Long Plat Initial Internal Review Comments

File Number: LP22-00002

Subject: LP22-00002 Sunfisher LCC 16.05.090 Review

LP22-00002 Sunfisher

f) Adequacy of Lot Arrangement and Driveway & Building Access

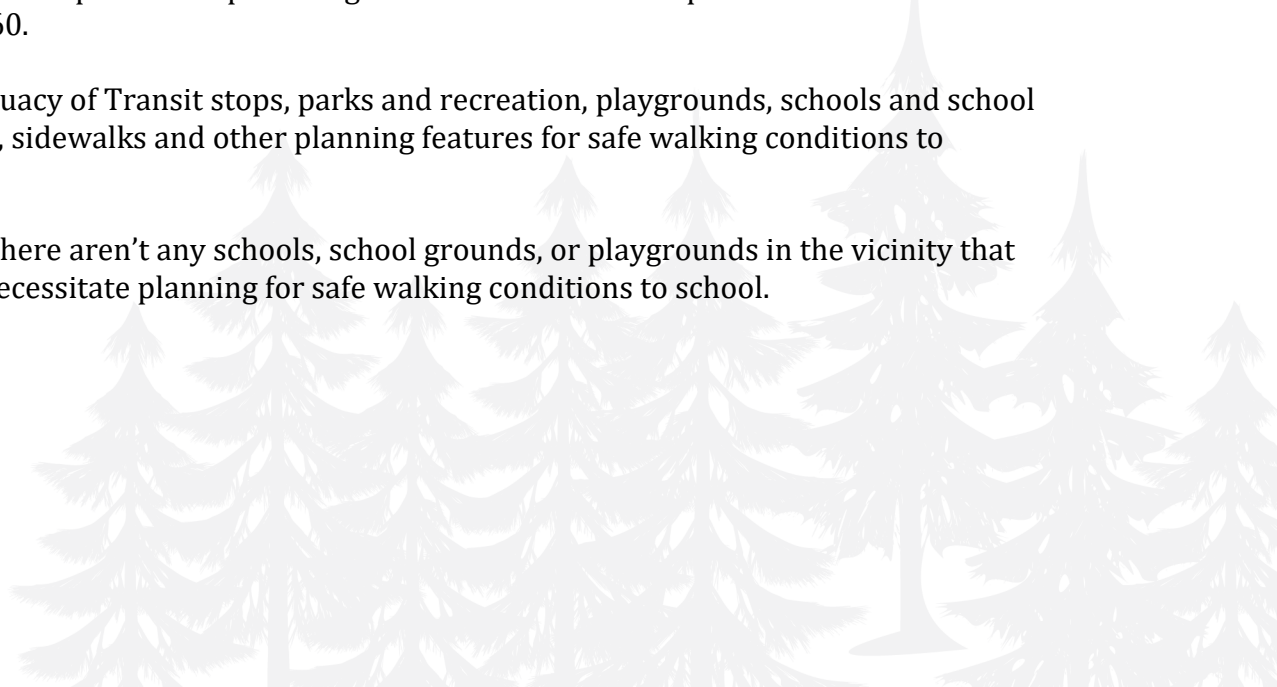
Lot arrangement will need to be adjusted to accommodate sixty feet of right-of-way to provide acceptable access to all lots via public roads. The arrangement shown provides adequate access for private roads.
